### **Central Zoo Authority**

F. No. 19-69/92-CZA (232)(Vol. IV)(M)

Sub:- Amended designs for the construction of various enclosures at Jaipur Zoo, Jaipur.

BIOLOGICAL PARK - NAHARGARH, JAIPUR

DATE: 4 JUNE 2012 SCALE: - 1:150
DRAWING NO.: BP/NHRGRH/10/SLOTH BEAR ENCLOSURE/02

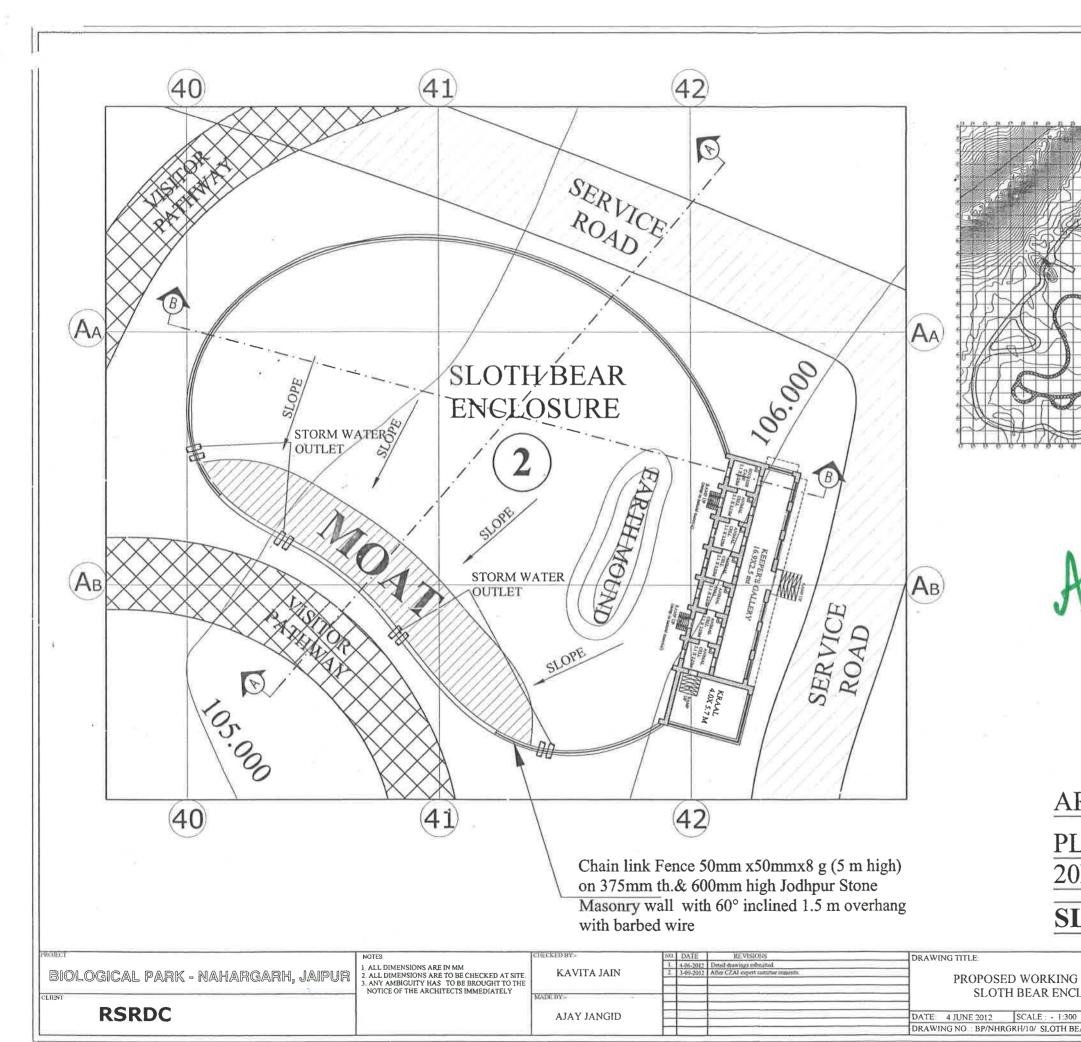
(ii) Construction of Sloth bear enclosure

The design was scrutinized and approved. (signed copy enclosed)
